SUBJECT: AMENDMENT NOS. 148 AND 134 TO FACILITY OPERATING LICENSE NOS. DPR-58
AND DPR-74: (TAC NOS. 75395, 75396 AND 76816)

COOK AMEND 75395/6 & 75816

AMENDMENT TO FACILITY OPERATING LICENSE

ATTACHMENT TO LICENSE AMENDMENTS

Figure 2.1-1 Reactor Core Safety Limits
Four Loops in Operation

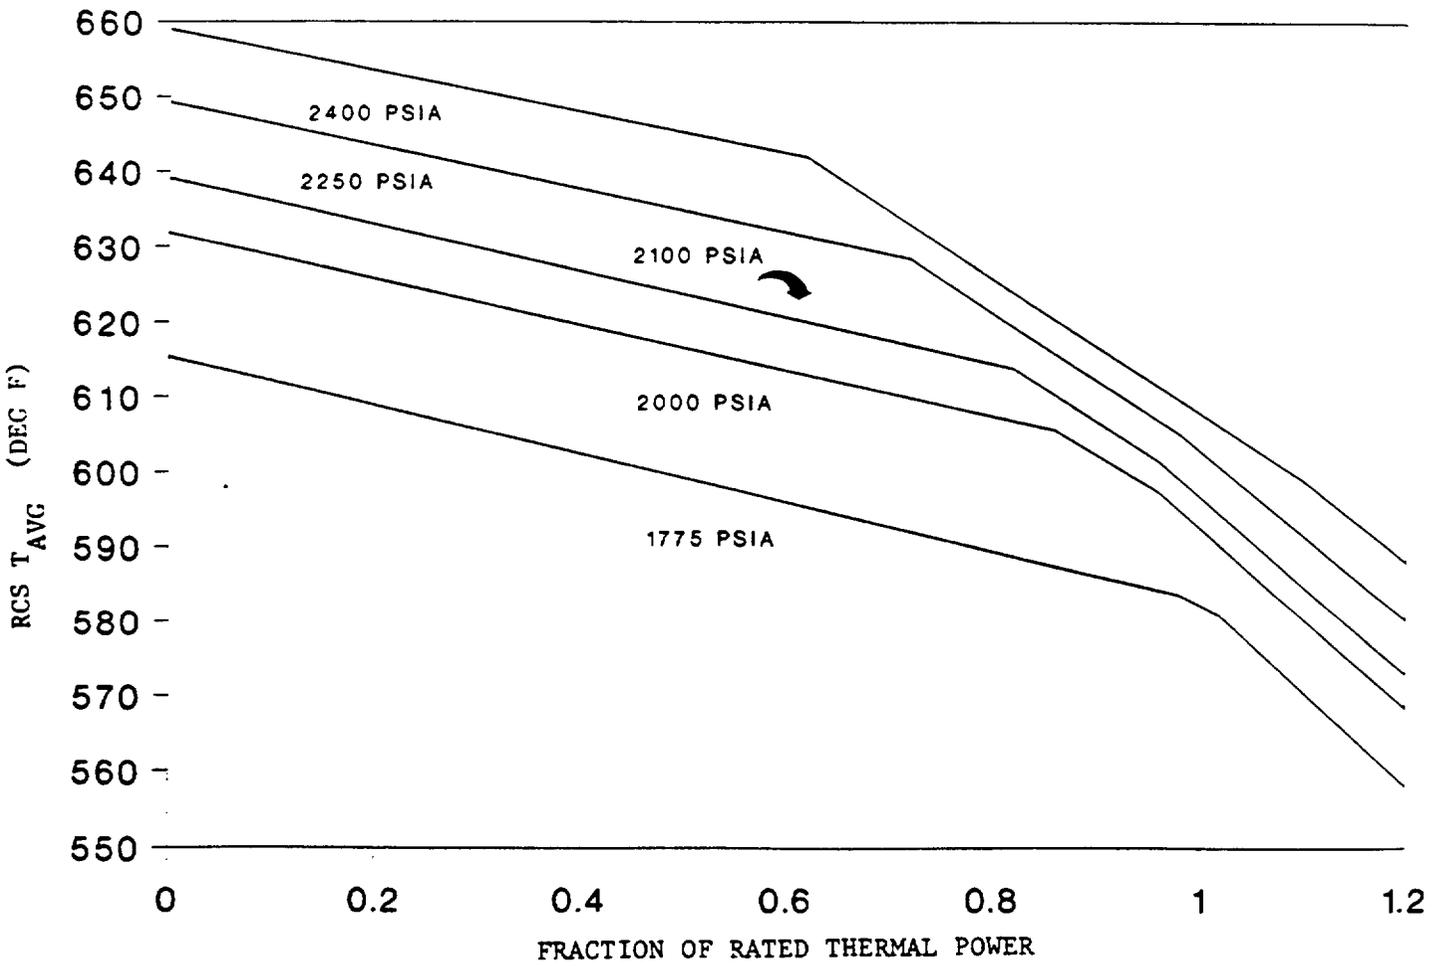
The curves of Figure 2.1-1 show the loci of points of THERMAL POWER, Reactor Coolant System pressure, and average temperature below which the calculated DNBR is no less than the design DNBR limit value or the average enthalpy at the vessel exit is less than the enthalpy of saturated liquid.
